Work Order ID: 138820

Parent Item Name: Quick Release Heli-Utility-Basket™ Long, HD Lid, Spacepod™/Squirrel Cheek Comp.

DART SERVICE INSTRUCTION

TO AMEND INSTALLATION INSTRUCTIONS D350-607-3 Rev.D,
INSTALLATION INSTRUCTIONS D350-607-4 Rev. C AND
INSTRUCTIONS FOR CONTINUED AIRWORTHINESS ICA-D350-607 REV. 6
REF TCCA STC: SH94-14
REF FAA STC: SR00213NY
REF EASA STC: EASA.10016996
REF BRAZILIAN STC: 2007S03-03/-04/-05/-06

FIGURE 1: INSTALLATION OF D4775-041 FWD STRUT

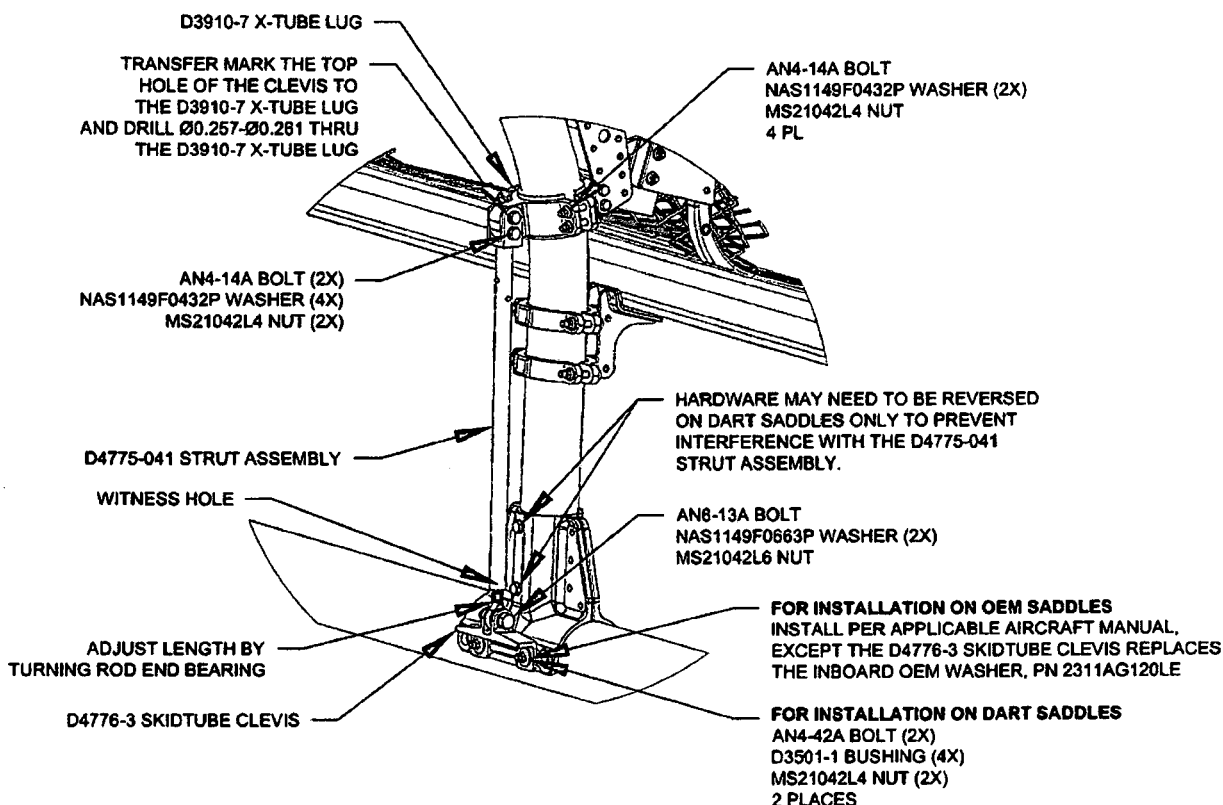
3.1 Substitute the Forward Lower D3910-5 X-Tube Lug with the D3910-7 X-Tube Lug as shown in Figure 1.

3.2 Install the forward D4775-041 Strut Assembly. Transfer mark from the upper hole on the clevis of the D4775-041 Strut Assembly to the D3910-7 X-tube Lug and drill thru the lug $\varnothing 0.257 - \varnothing 0.261$ as shown in Figure 1. Touch up chemical conversion coating per MIL-DTL-5541. Check the witness holes located at the bottom end of the D4775-041 Strut Assemblies to ensure that the thread from the rod end extends past the witness hole.
Torque MS21042L4/-4 nuts to 50-70 in-lbs (5.7-7.9 N-m). Torque MS21042L6/-6 nuts to 160-190 in-lbs (18.1-21.5 N-m).
